# Planning Commission Report

**Meeting Date:** August 11, 2016

**Subject:** **331 North Oakhurst Drive  
New Three-Story Dwelling Unit**  
Request for Variances and a Development Plan Review to allow the construction of a three-story building on the property located at 331 North Oakhurst Drive.

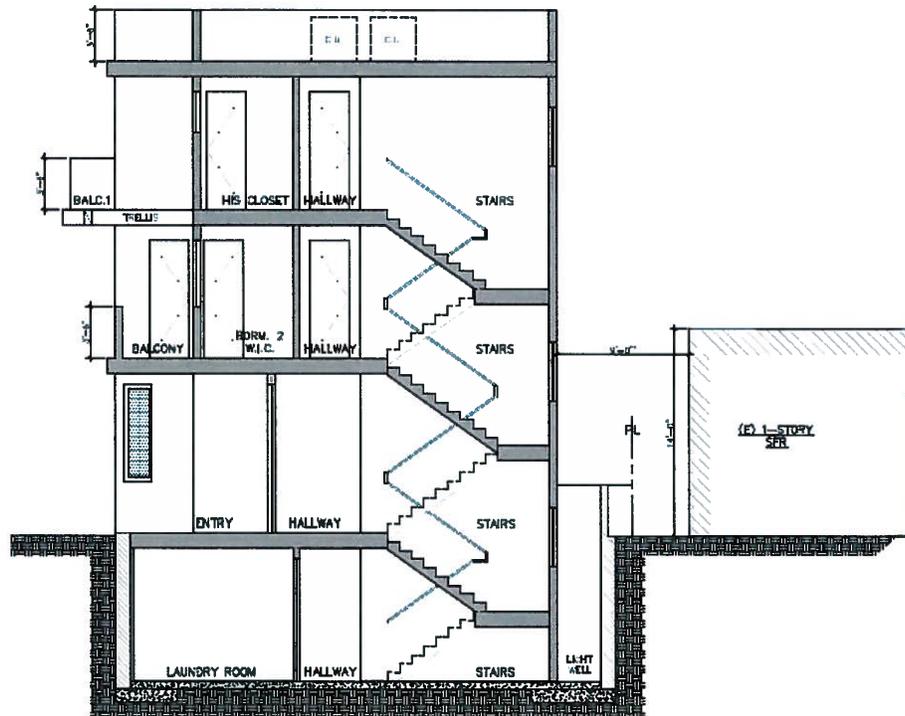
**Height and density:**

The project is 32'2" in height and consists of 3,724 square feet on a 3,327 square foot property. The maximum height for buildings in this multi-family zone is 33'. The City's multi-family standards identify a 1,500 square-foot minimum floor area for a three or more bedroom unit and does not define a maximum floor area ratio for multi-family projects. The one unit proposed is less than the allowed density of two units for this multi-family property.

The project does exceed the theoretical maximum floor area otherwise permitted on the site if all required setbacks were met, and there was no habitable dwelling unit floor area on the basement level (consistent with current multi-family standards). If a three story building were built within the required setbacks and with the required modulation for multi-family buildings the maximum floor area would be approximately 2,205 square feet, which is 1,519 square feet smaller than the proposed structure.

The project applicant is seeking several variances related to the setbacks on the property. First, the applicant is requesting to reduce the rear yard setback from the required 15 feet to the proposed 5 feet. The reduced rear yard setback would allow the project to be constructed approximately 9 feet from the neighboring single family home to the rear of the subject property. Additionally, the applicant is requesting to allow the extension of the basement lightwell to encroach into this rear yard setback. The proposed lightwell would encroach a total of 3'6" into the provided 5' rear yard setback leaving 1'6" of plantable land adjacent to the neighbor to the rear of the property (see following image). The encroachment of the light well into this area would greatly decrease the ability to provide landscaping to screen views of the proposed three story building from the neighboring property.

Finally, the applicant is requesting that a required parking space be allowed to encroach six feet into the required front yard setback. The request to allow parking in the front yard requires a variance from the requirements for parking in multi-family areas, which must meet the following requirements: 1) located outside the front yard setback, and 2) located in a structure and completely shielded from public view. The proposed location would result in the view of parked cars on the property from the public right of way.

Staff has expressed concerns to the applicant regarding the reduced rear yard setback including the encroachment of the basement lightwell into this area, as it would greatly reduce the ability to shield the property from the neighboring single-family home, and would generally preclude any time of meaningful buffer between the properties. Additionally, the reduced rear yard setback would allow the construction of the building nine feet from the existing neighboring single family home. The proposed building is approximately 19 feet taller than the existing neighboring single family home, and staff has concerns about the neighbors access to light and air as well as concerns related to privacy should the project be approved as presented. Accordingly, staff does not support the requested setback reductions.

BHMC § 10-3-2818 requires that parking in multi-family zones is provided within a structure and is completely shielded from public view. The applicant is proposing the provision of two uncovered parking spaces located in the north side yard of the property. These parking spaces would not be shielded from public view and would also be located partially in the front yard setback. The two unshielded parking spaces will also have no setback from the directly adjacent residential property to the north with a six foot tall chain link fence as the only proposed barrier.

Staff has expressed concerns to the applicant about the provision of parking in an unshielded manner, as it is not consistent with the existing zoning regulations and the prevailing pattern of development in multi-family zones in the City. The shielding of parked cars in multi-family neighborhoods can reduce visual clutter in multi-family neighborhoods and also addresses potential noise related issues.

For these reasons, staff does not recommend approval of the variances pertaining to parking location and shielding, and would instead encourage required parking to be provided within a fully enclosed structure.
